# City of Albuquerque P.O. BOX 1293 ALBUQUERQUE, NEW MEXICO 87103

RE: Grading and Drainage Plan For Bataan Memorial (J16-D15) Dated September 7, 2001

TITLE: BATAAN MEMORIAL DRAINAGE PLAN AND CALCULATIONS Design Review Committee City Engineer Approval

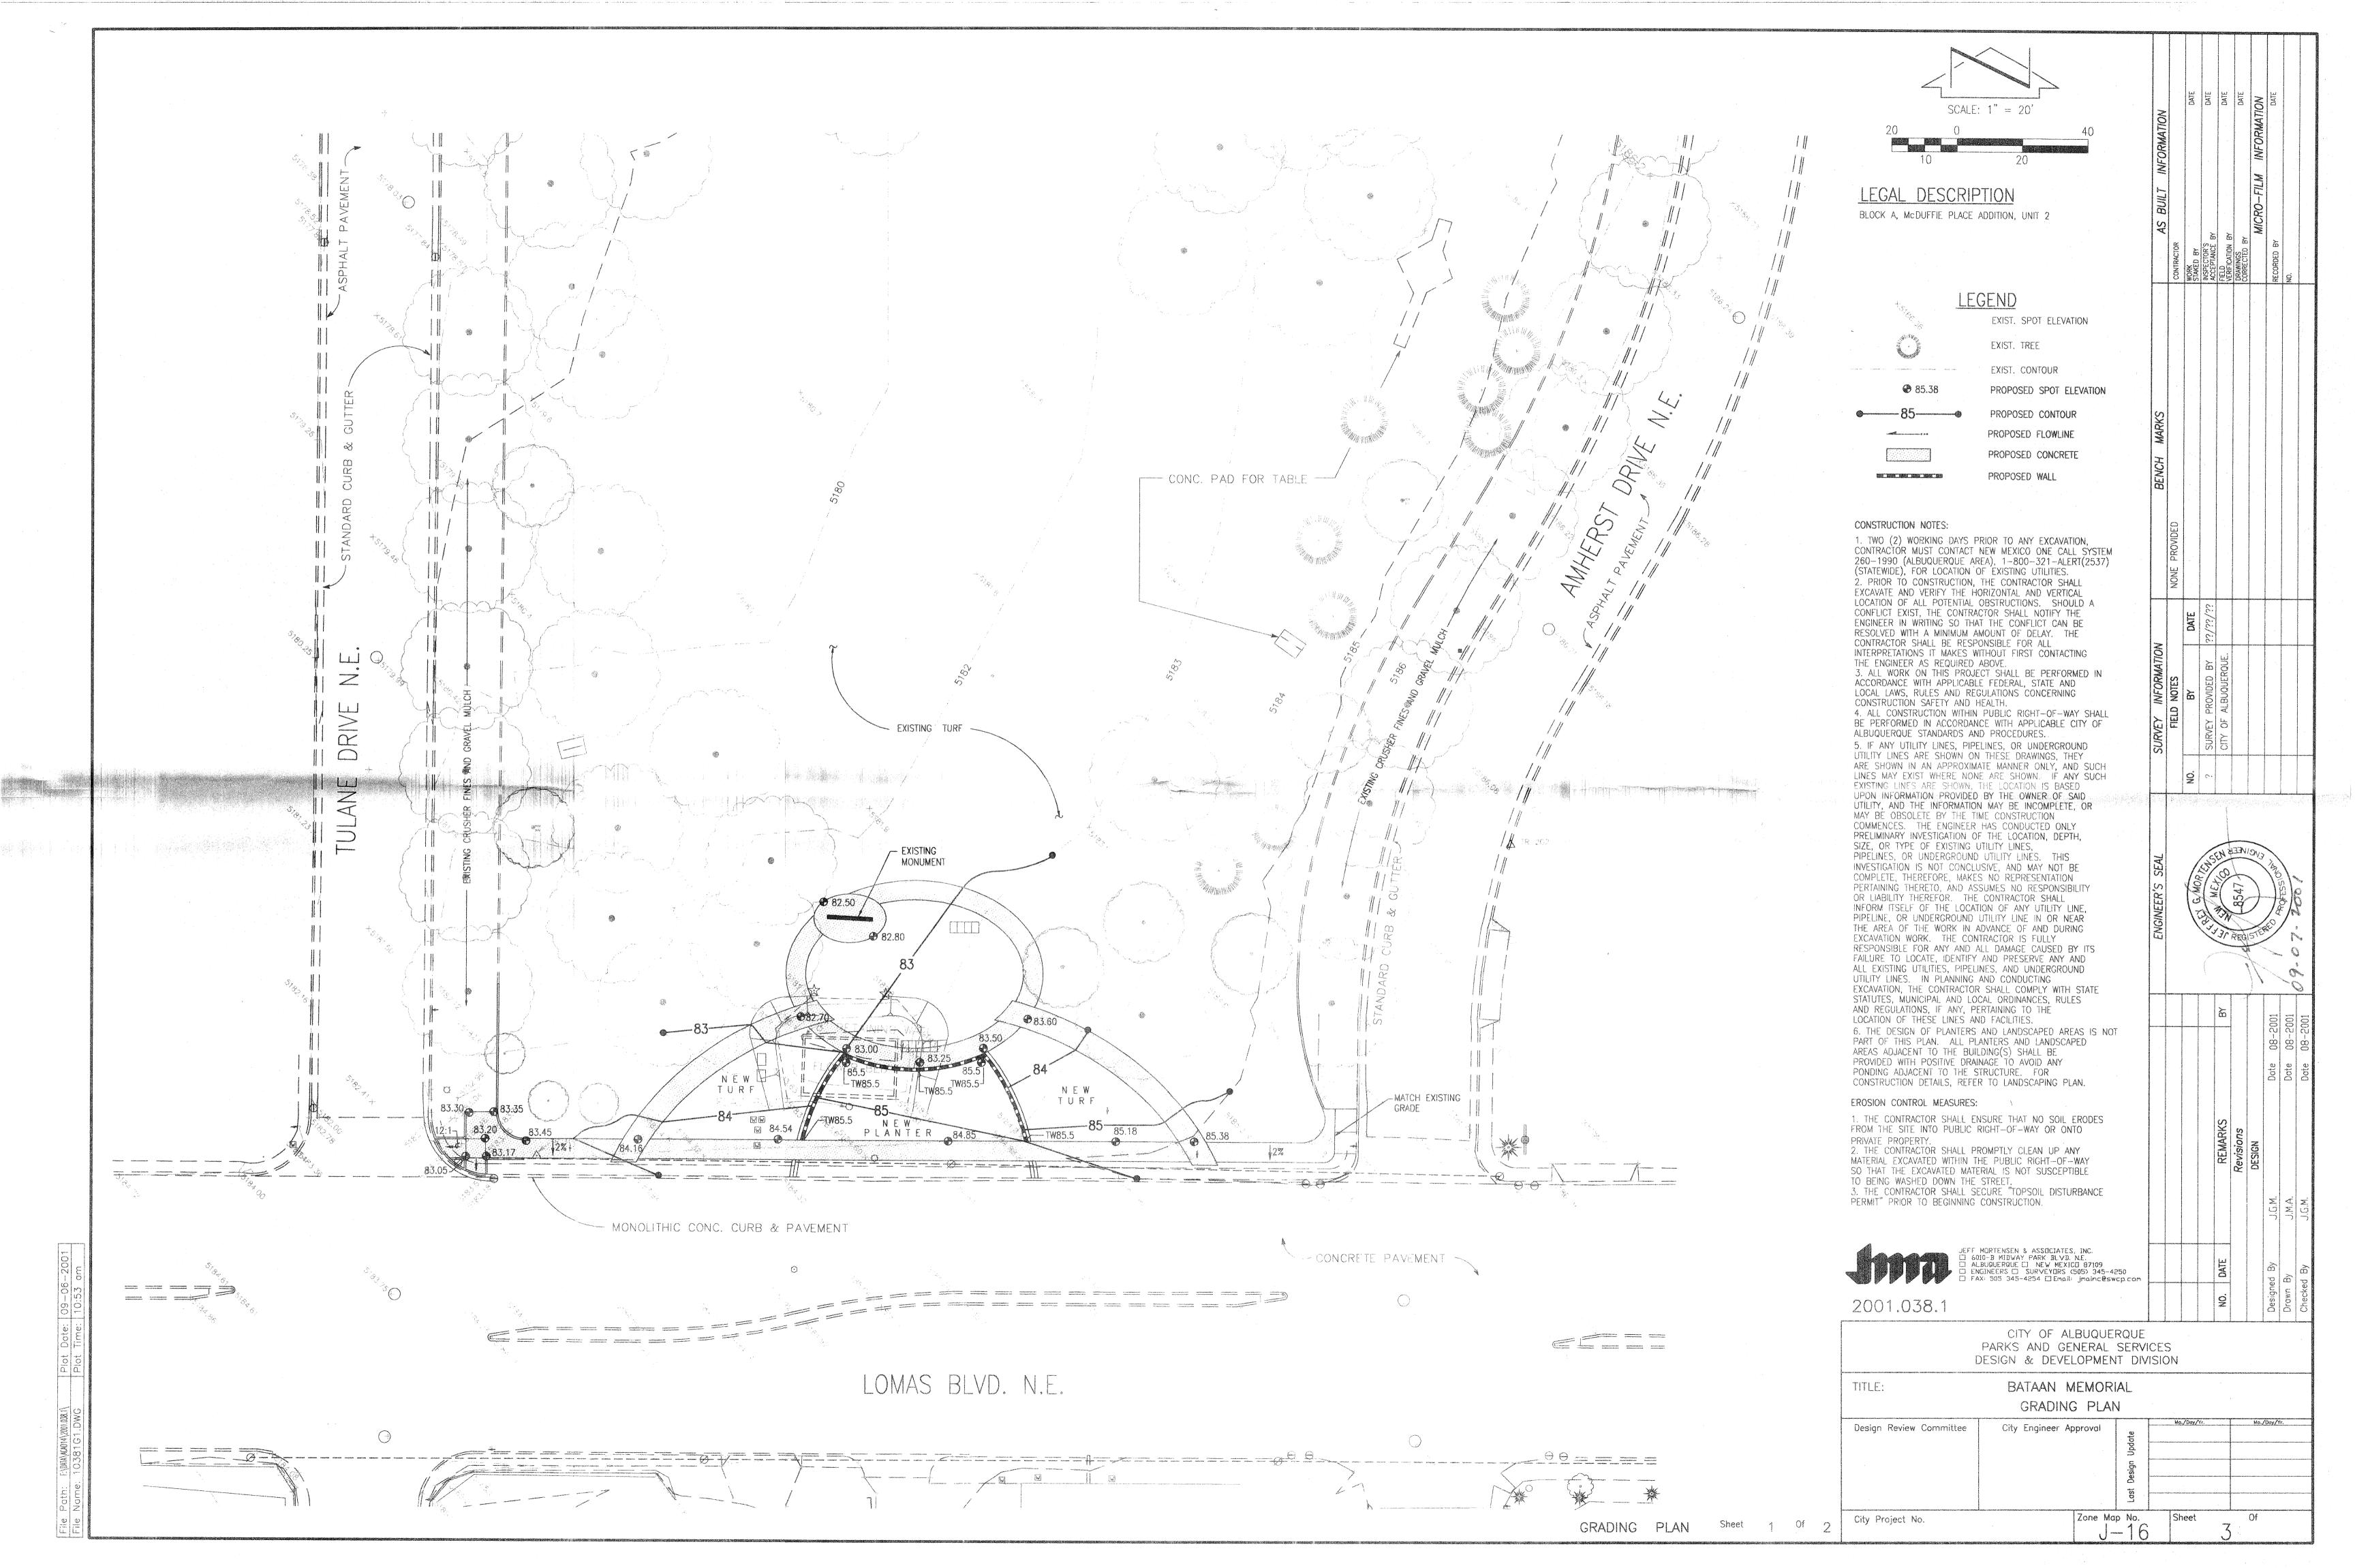
The above referenced drainage plan received September 7, 2001 is approved for DRC approval by Hydrology.
